TECHNICAL SERVICE BULLETIN

Technical Service Bulletin: 225-1190

Forest River is alerting you to an issue involving certain 2021 – Class B Motor Home Recreational Vehicles. Please see the information below, which describes the issue and provides you with details on the steps you should take to have your vehicle repaired.

Subject: Lead rail Connector Locking Washer Replacement

Screw location between lead rail and casting

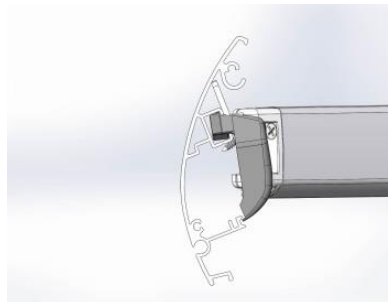
- 5) Install washer locking screw in the Lead rail locking washer slot, located directly below the bolt. It may be necessary to press up on the canopy slightly to obtain the correct angle for driving the screw.

Screw head location, under bolt head
